**FEDERAL AVIATION ADMINISTRATION  
AIRWORTHINESS DIRECTIVES**

**SMALL AIRPLANES, ROTORCRAFT, GLIDERS,  
BALLOONS, & AIRSHIPS**

**BIWEEKLY 2013-08**

*4/8/2013 - 4/21/2013*

**Figure 1 to Paragraph (e)(1)**

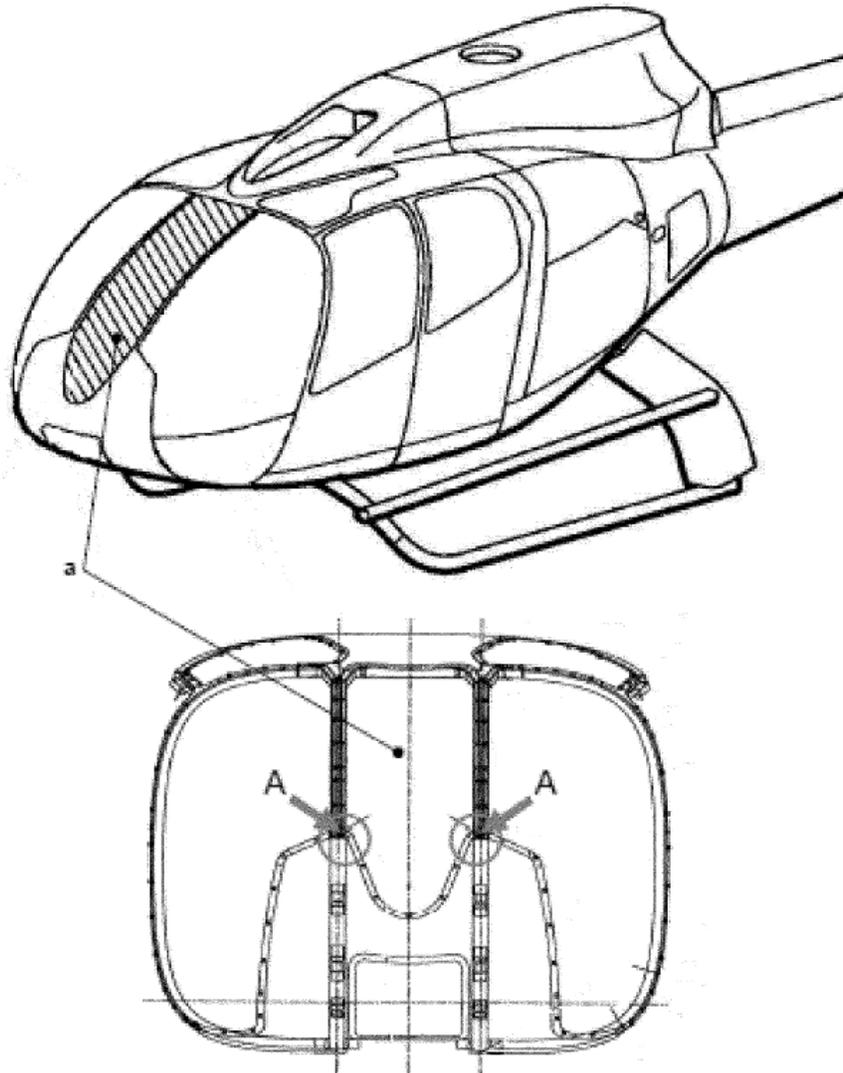
This AD defines the unsafe condition as a crack in the blending radii of the center windscreen, which could lead to failure of the center windscreen, injury to the flight crew, and subsequent loss of control of the helicopter.

(1) Until the center windscreen is replaced with center windscreen P/N 350A25-9045-20, before each flight, visually check the center windscreen for a crack in the area of the blending radii where the front-lower part of the center windscreen joins the front fuselage as depicted in Figure 1 to paragraph (e)(1) of this AD. This visual check may be performed by the owner/operator (pilot) holding at least a private pilot certificate, and must be entered into the aircraft records showing compliance with this AD in accordance with Title 14 Code of Federal Regulations (14 CFR) 43.9 (a)(1)-(4) and 14 CFR 91.417(a)(2)(v). The record must be maintained as required by 14 CFR 91.417, 121.380, or 135.439.

(2) If there is a crack or if a pilot indicates that the center windscreen distorted during flight, before further flight, replace the center windscreen with an airworthy center windscreen, P/N 350A25-9045-20, in accordance with the Accomplishment Instructions, paragraphs 2.B.2.b. through 2.B.2.b.4., of Eurocopter Service Bulletin No. 56-003, Revision 0, dated November 16, 2010.

(3) Within 12 months, replace the center windscreen with an airworthy center windscreen, P/N 350A25-9045-20, in accordance with the instructions contained in paragraph (e)(2) of this AD.
